**STAFF REPORT
PLANNING MANAGER DECISION**

DATE: June 24, 2022
FILE NO.: DR-22-02
REQUEST: Approval of a Class I Historic Design Review at 1795 Willamette Falls Drive
PLANNER: John Floyd, Associate Planner

**ADDENDUM
APPROVAL CRITERIA AND FINDINGS
DR-21-12**

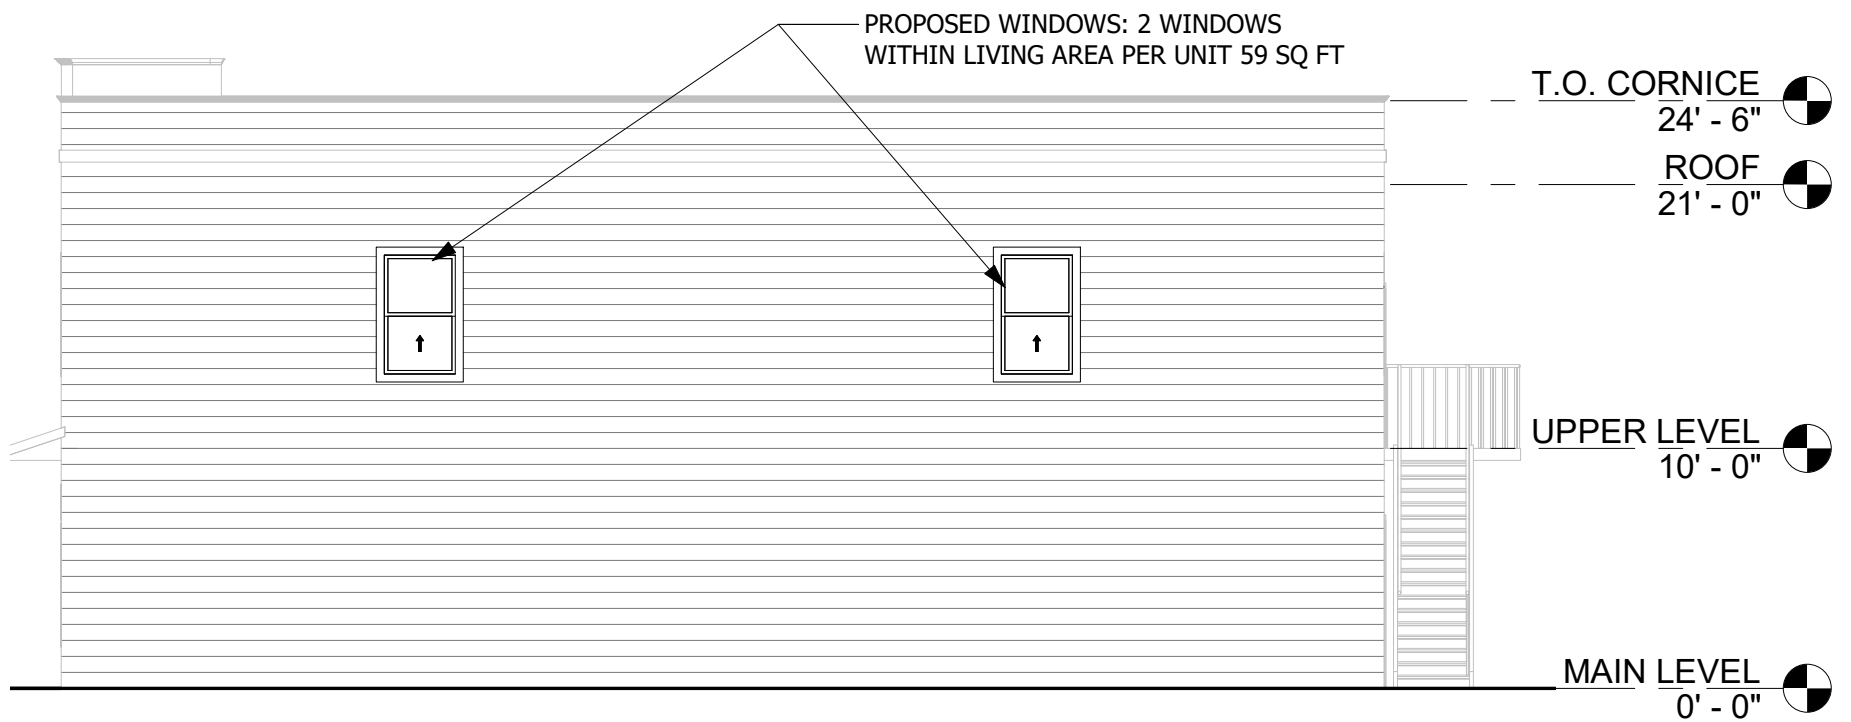
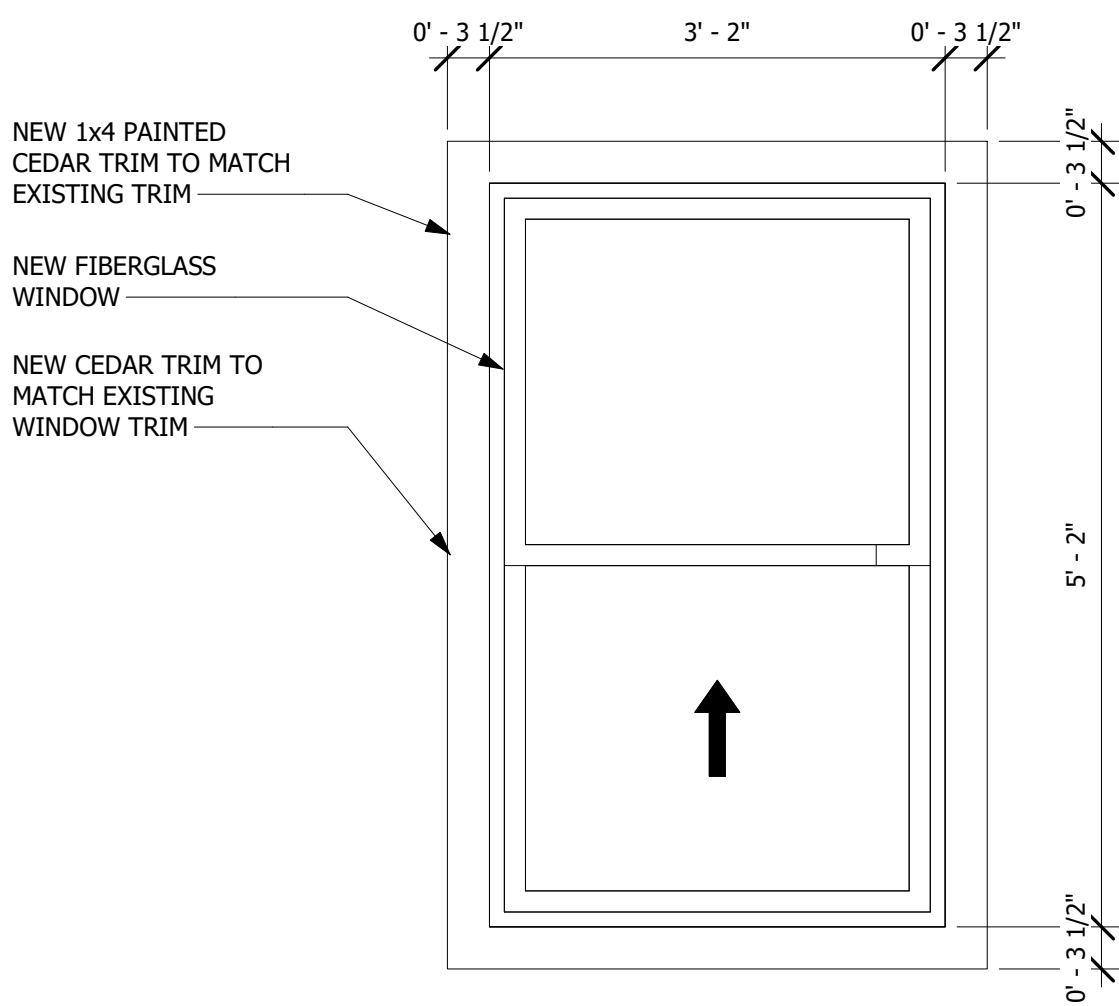
Staff Finding 2: The proposed façade alteration is subject to Class I Historic Design Review as it alters less than 100 square feet of the rear (south) and interior side (west) facades. More specifically, the proposed windows would alter approximately 88.5 square foot exterior alteration of the structure per sheet DR-5 of the proposed plans (Exhibit PD-1). This standard is met.
